CAUTION

The 627H, 632H Series detectors have been improved for easier field wiring. An external jumper connecting screw terminals 3 and 4 indicates that the unit was built prior to the change. These units must be wired as shown below.

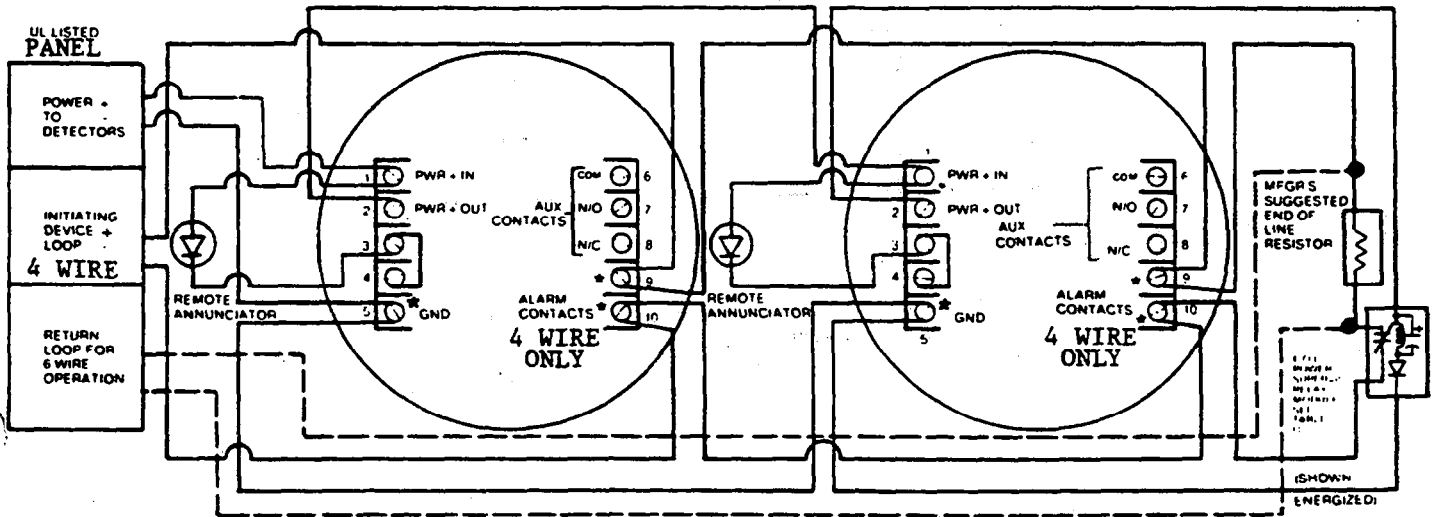
*CAUTION: Do not use looped wire under terminal. These terminals are designed to prevent looping a single wire which requires supervision. The wire

should be cut and stripped of 3/8" insulation on each end and inserted under the clamping plate, one wire on each side of the screw.

All units without this jumper must be wired per enclosed installation instruction, 156-147-00 (or 156-148-00).
